16092A-03

S E R V I C E N O T E

16092A Spring Clip Fixture

Serial Numbers: MY43101351- MY43201551, SG43100127 - SG43200132

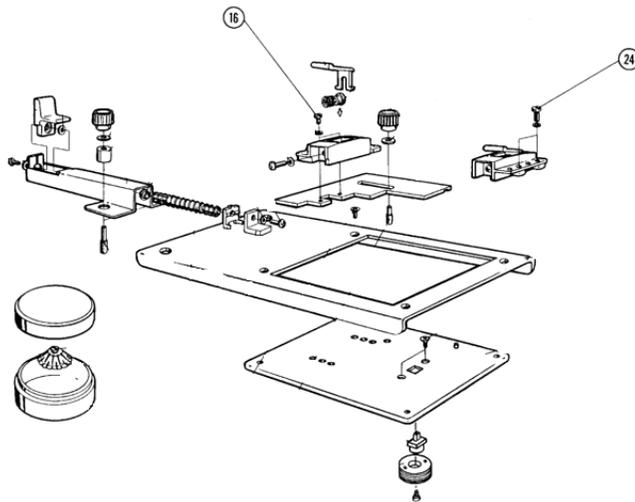
If the 16092A is faulty, the measured impedance is around 1 k ohm.

On the other hand, if the 16092A is normal, the measured impedance is very high.

Replace 16092-40616 with new ones.

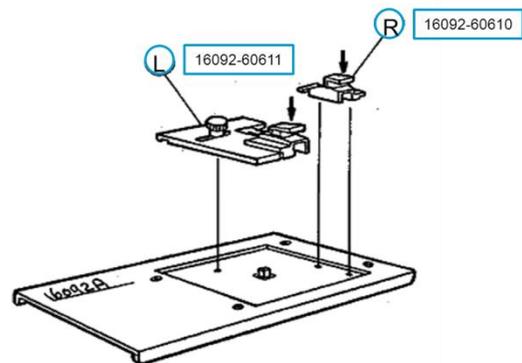
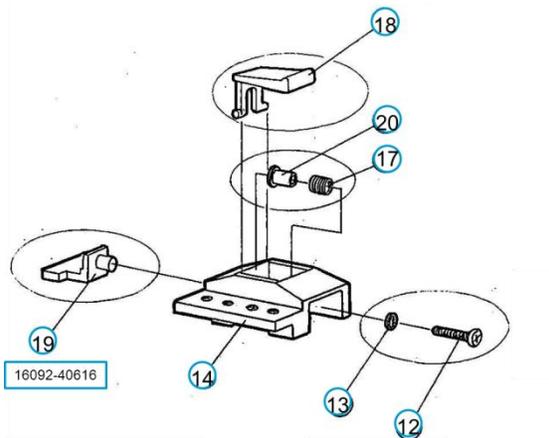
The conductivity of the defective holder (16092-40616) causes the Q measurement abnormally

Step-1: Loosen item 24 and item 16.

Step-2: Loosen item 12 and 13, then replace item 19 with new one for 16092-60610.

Step-3: Loosen item 12 and 13, then replace item 19 with new one for 16092-60611.

Step-4: Fasten item 16 and item 24.
